ADDENDUM NO. CC-3

TELEGRAPH DISTRICT  
401 BUILDING RENOVATION  
LINCOLN, NEBRASKA  
DLR GROUP PROJECT NO. 10-16202-00

COMBINED CONTRACT

March 21, 2016

# STRUCTURAL DETAILS TELEGRAPH DISTRICT 401 BUILDING RENOVATION

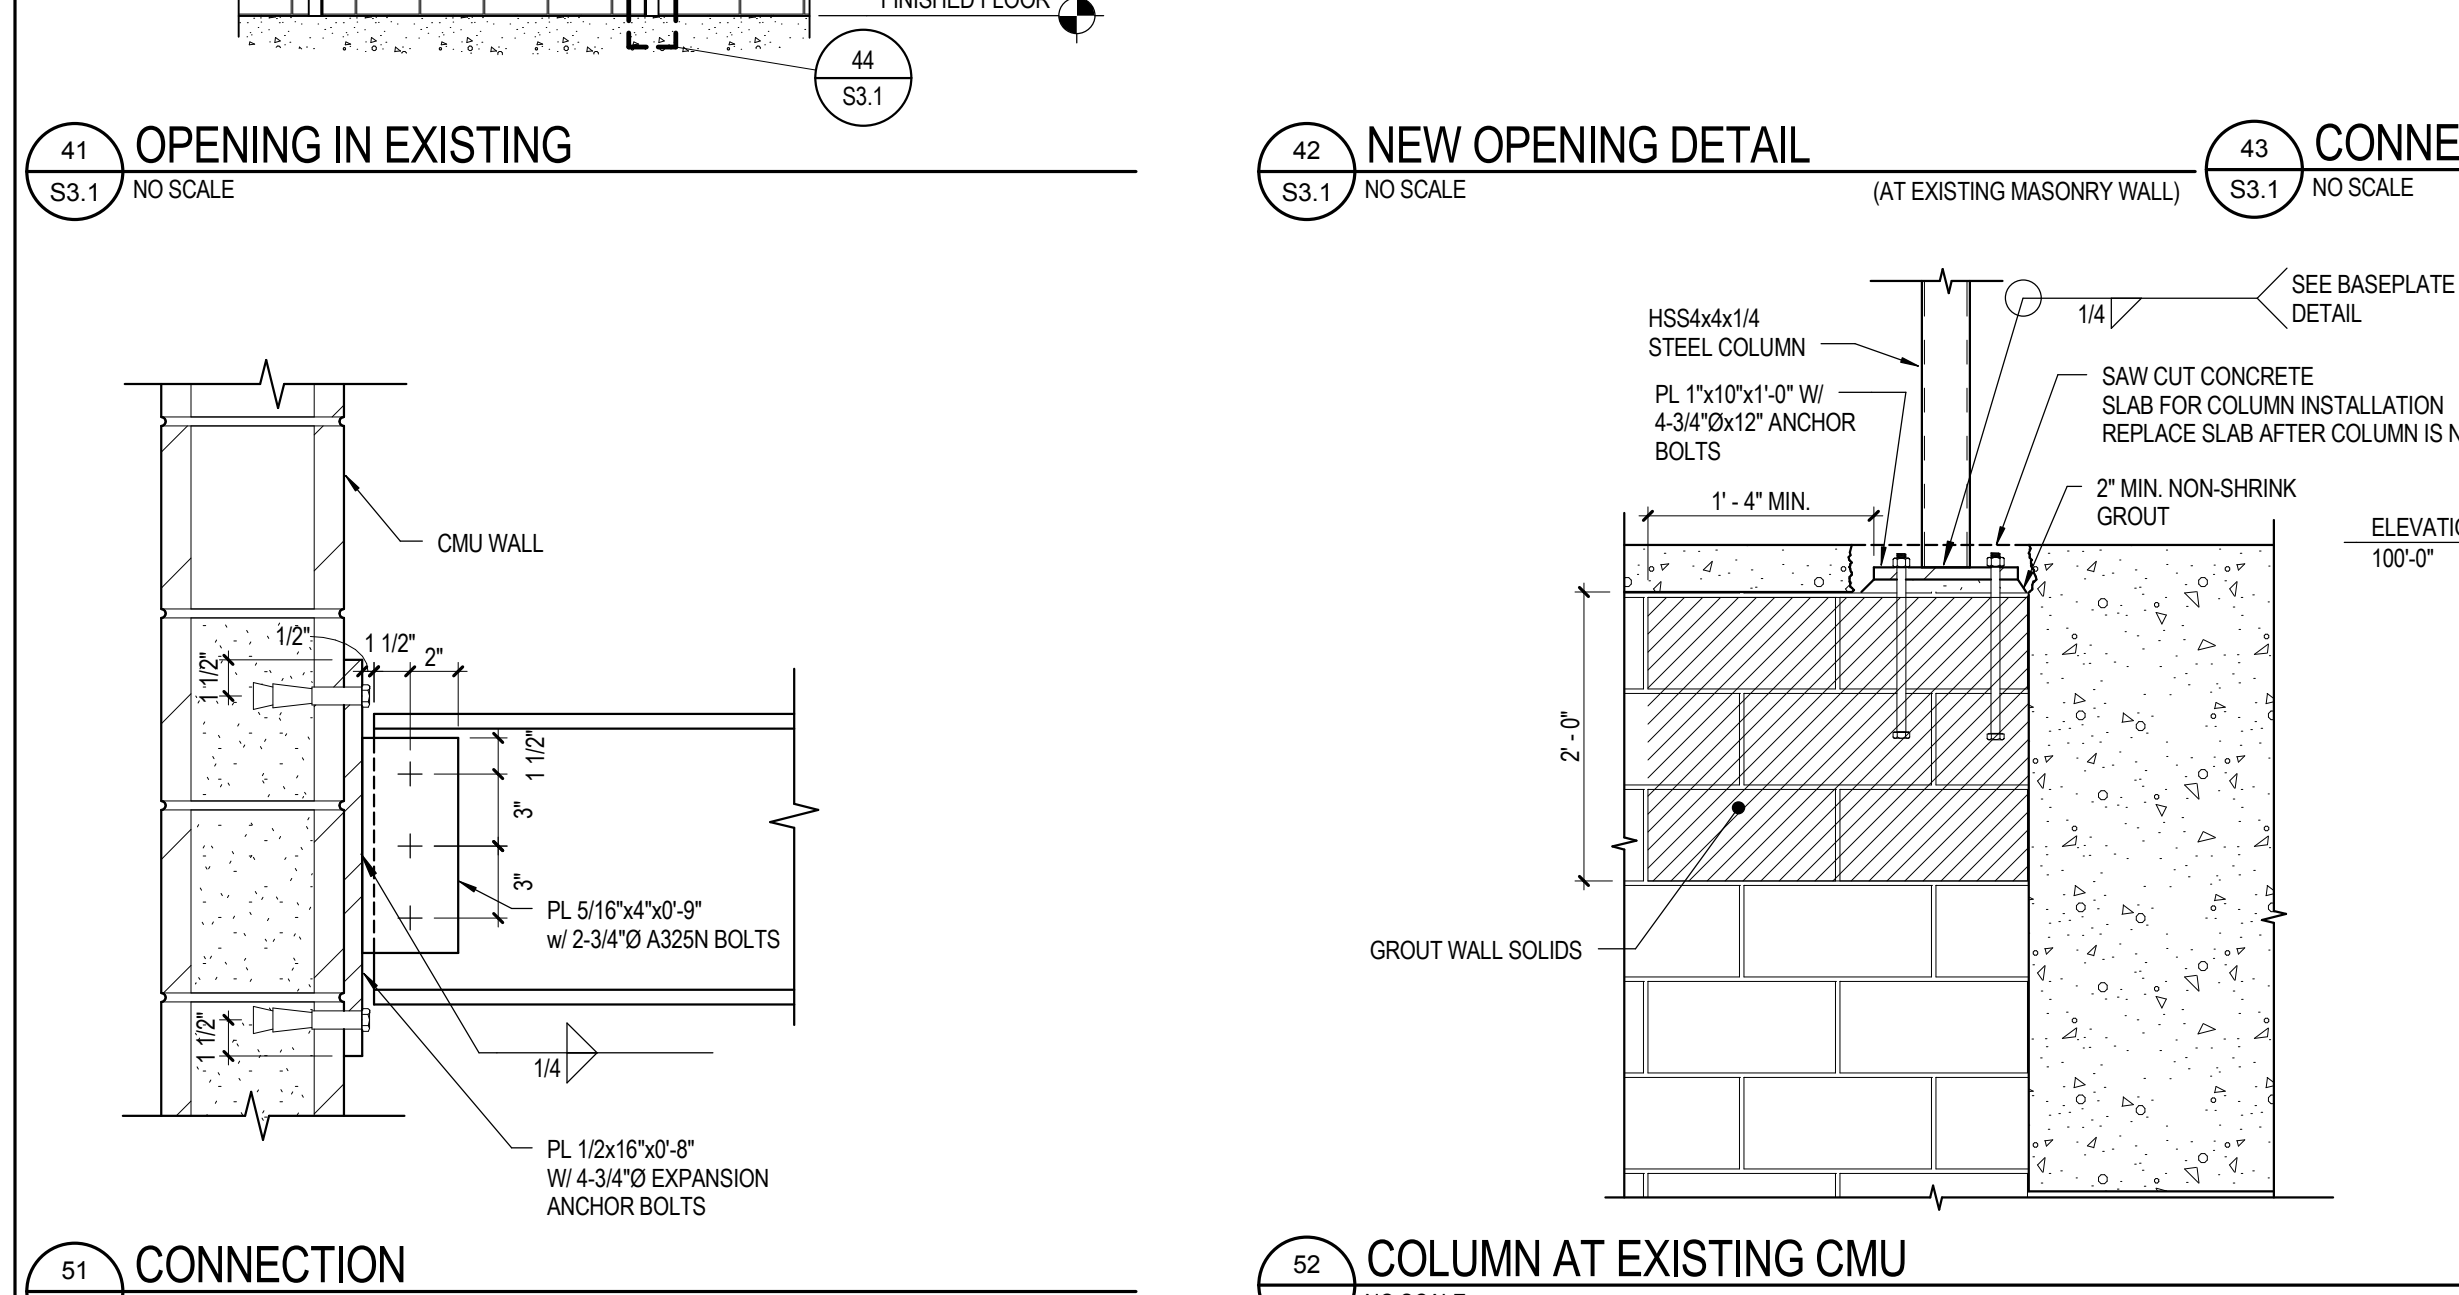
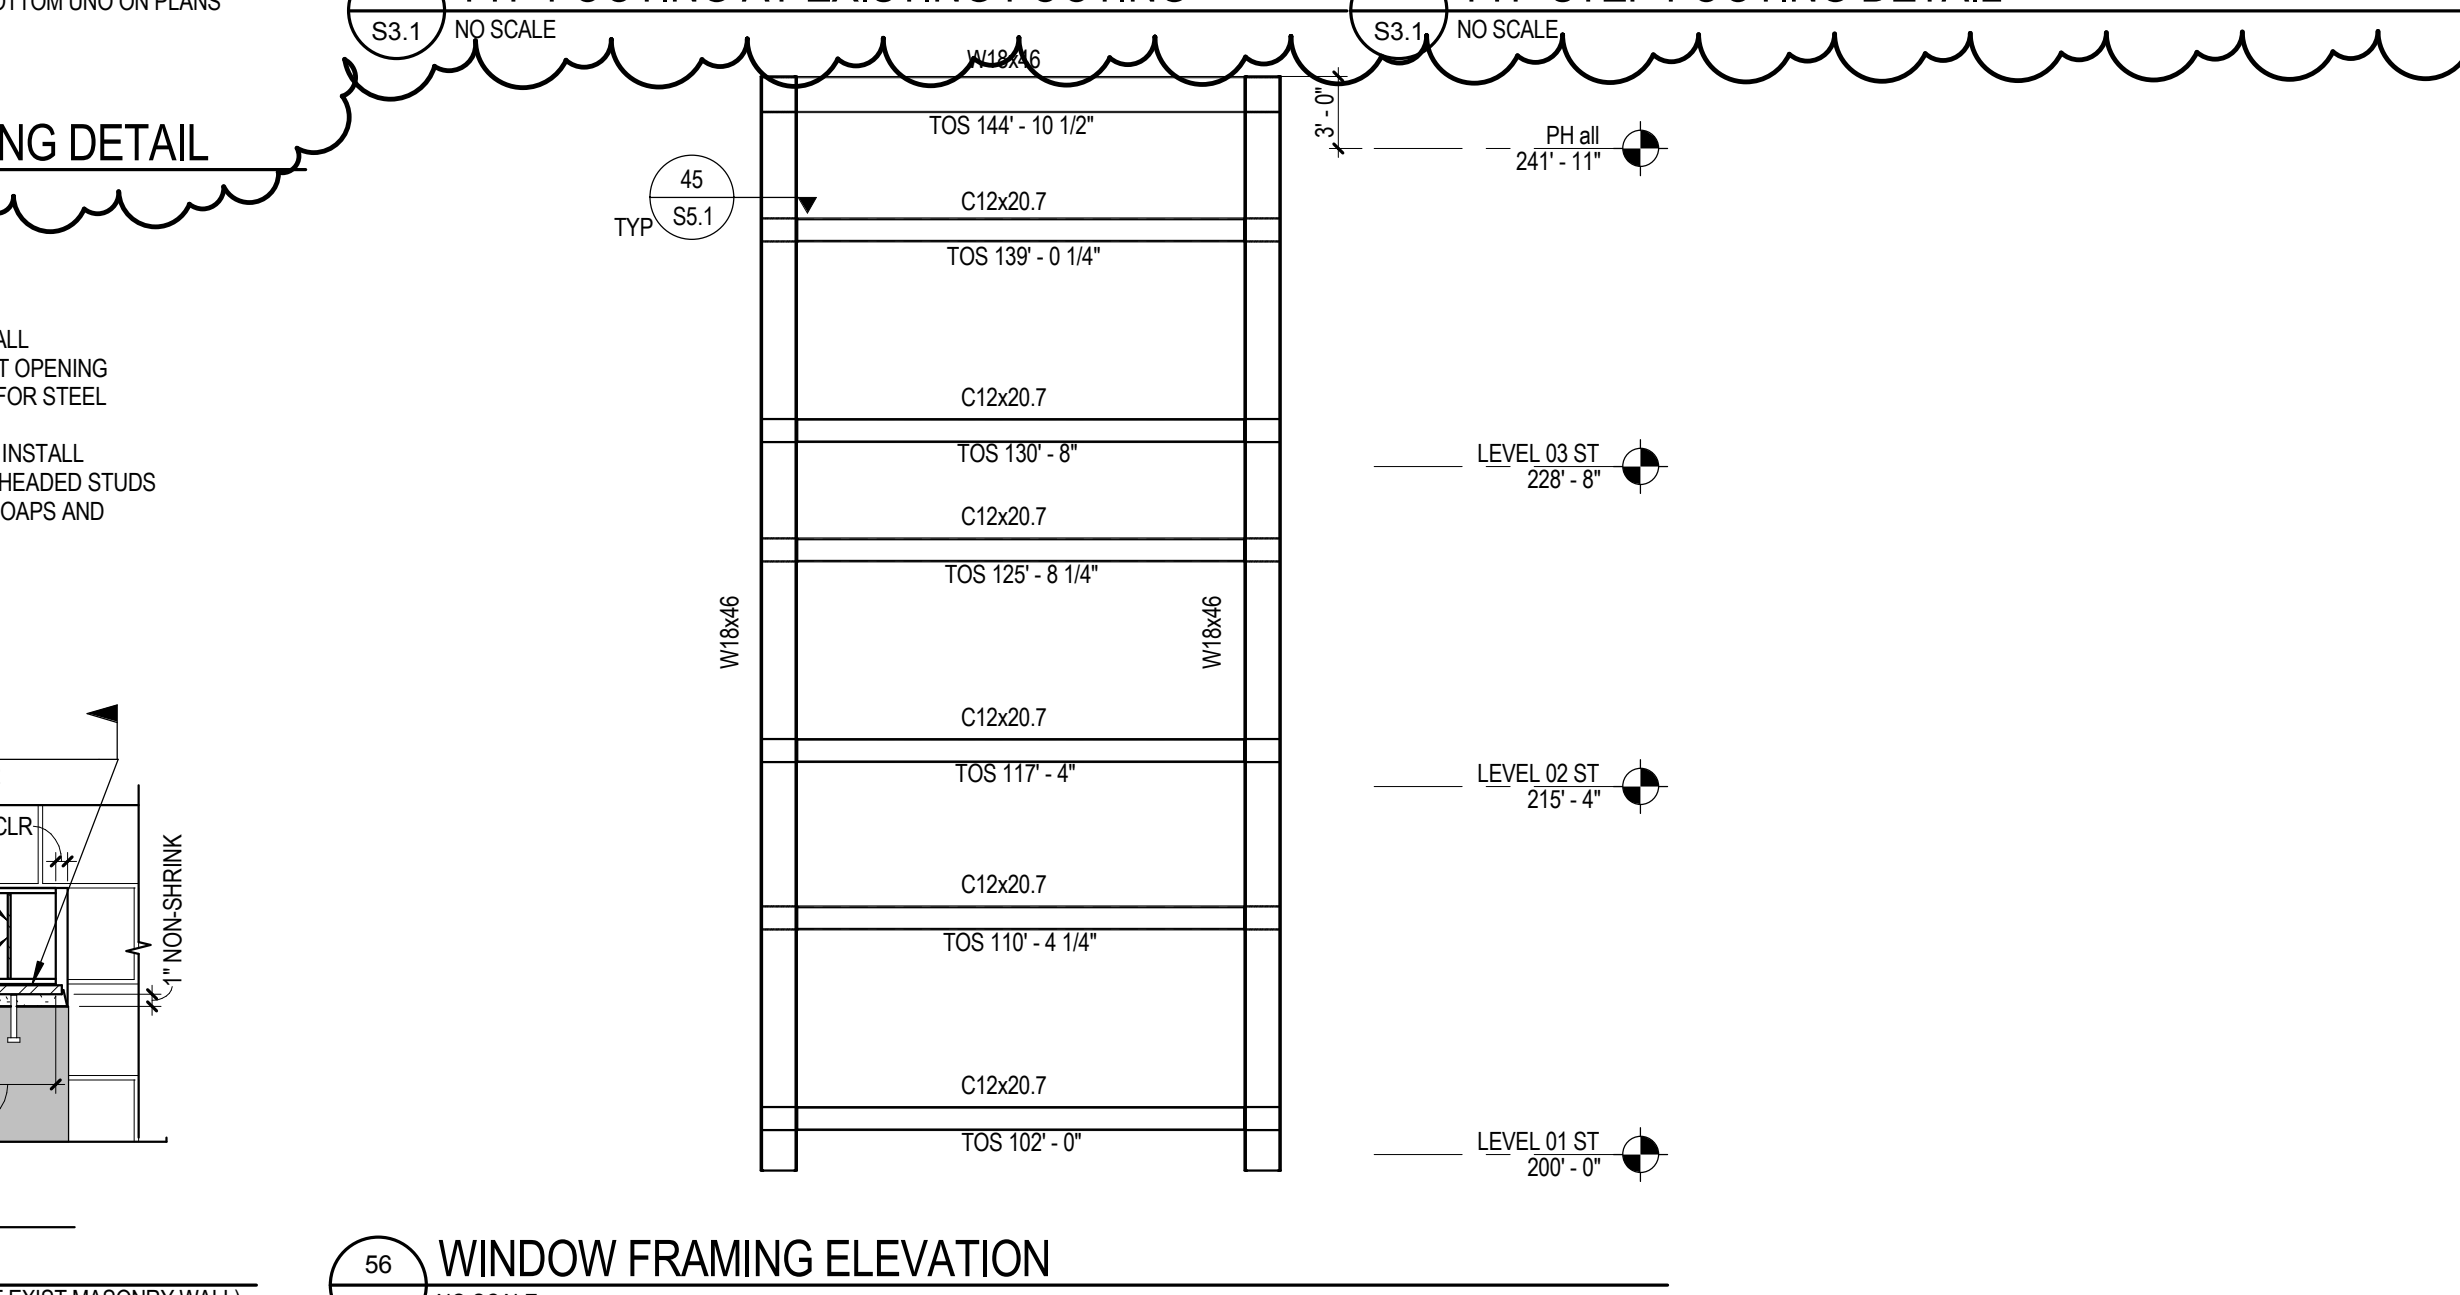
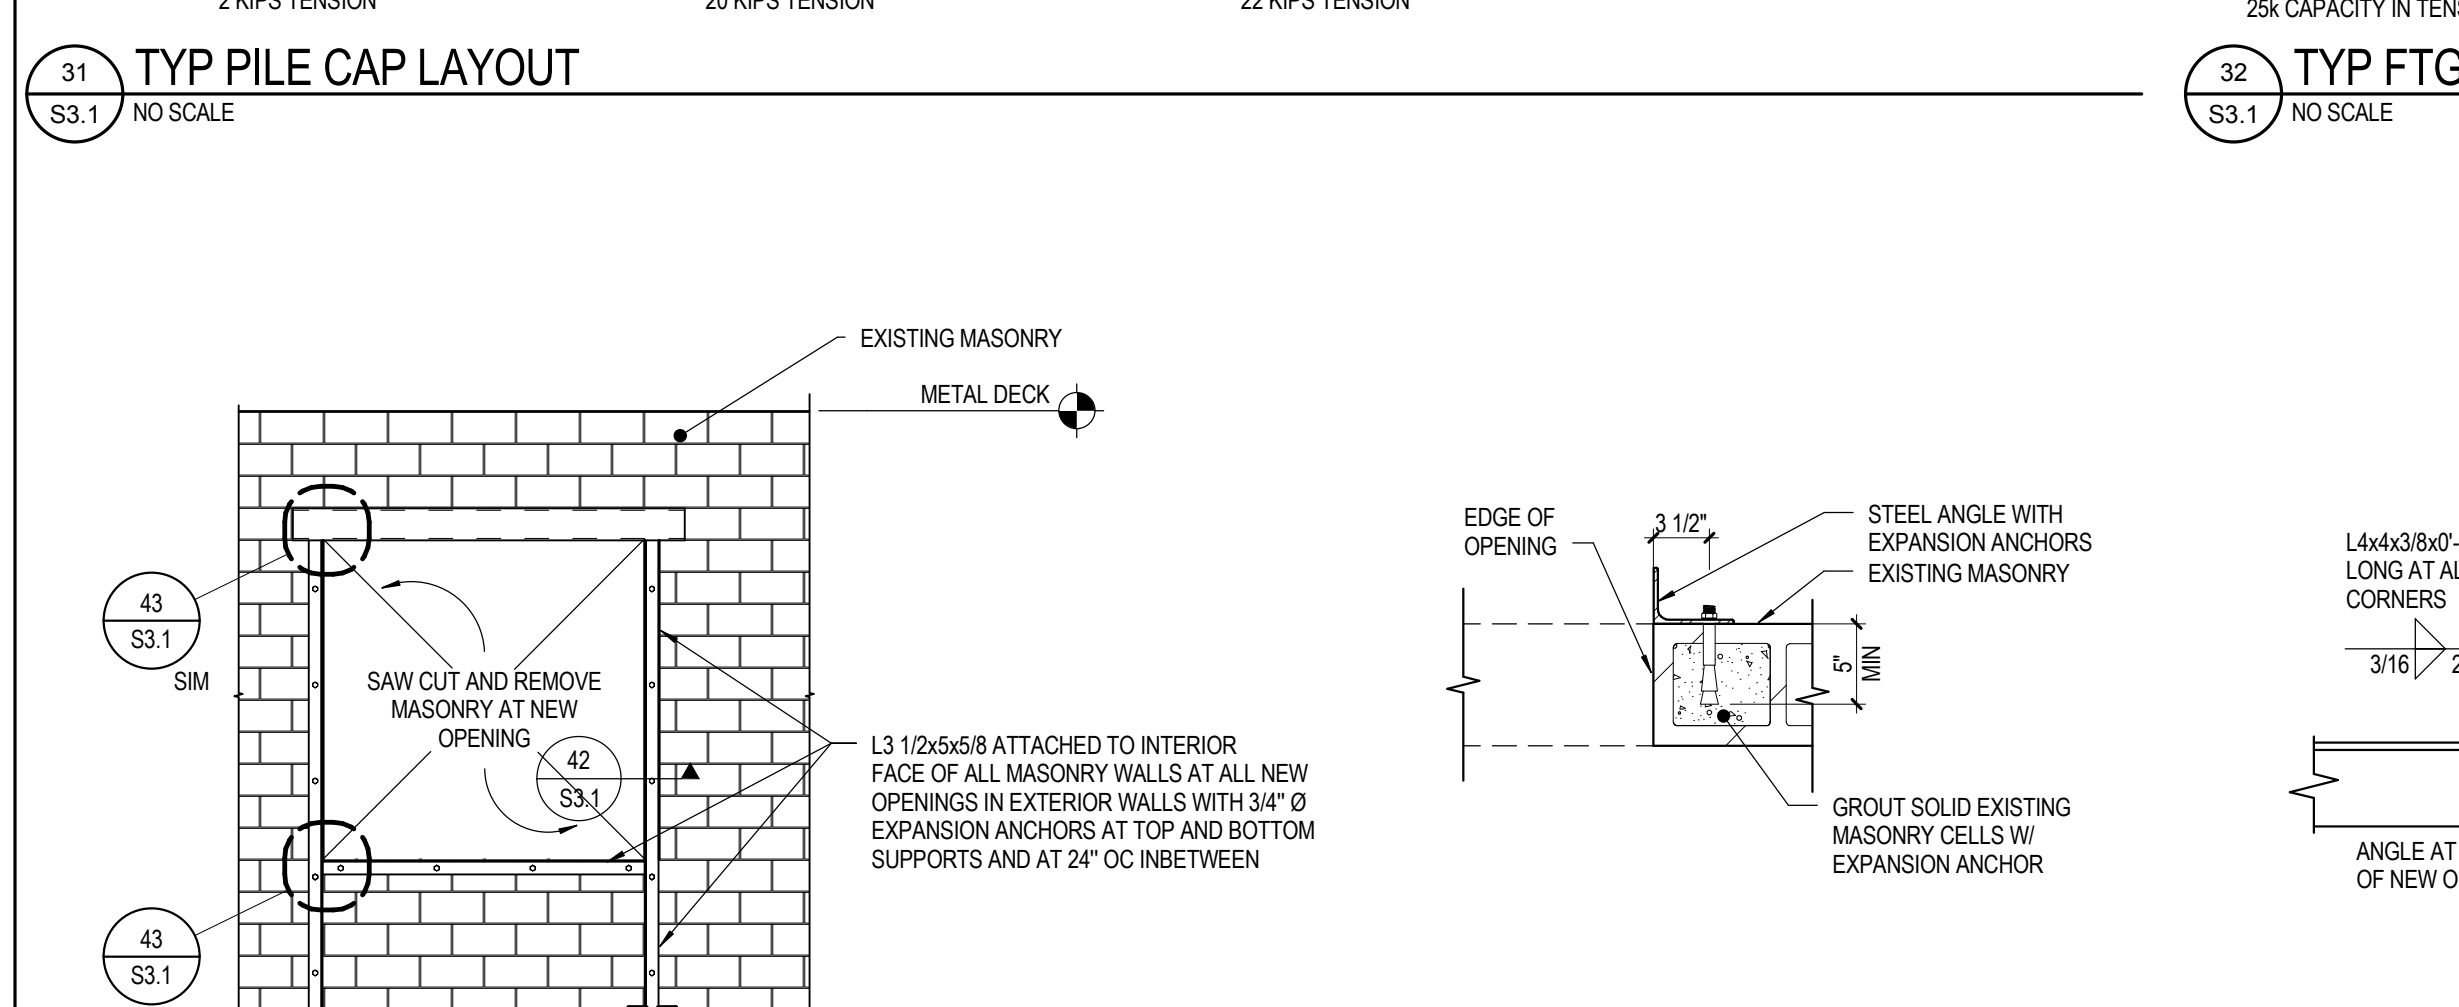
ITEM NO. 7 DRAWING S3.1 STRUCTURAL DETAILS

- A. Modify drawings as shown on Attachment S3.1-1
- B. Modify detail 35/S3.1 TYP COLUMN COVER DETAIL
- C. Add detail 36/S3.1 BASE PLATES
- D. Add detail 45/S3.1 TYP CONCRETE WALL FOOTING DETAIL
- E. Add detail 46/S3.1 TYP FOOTING AT EXISTING FOOTING
- F. Add detail 47/S3.1 TYP STEP FOOTING DETAIL
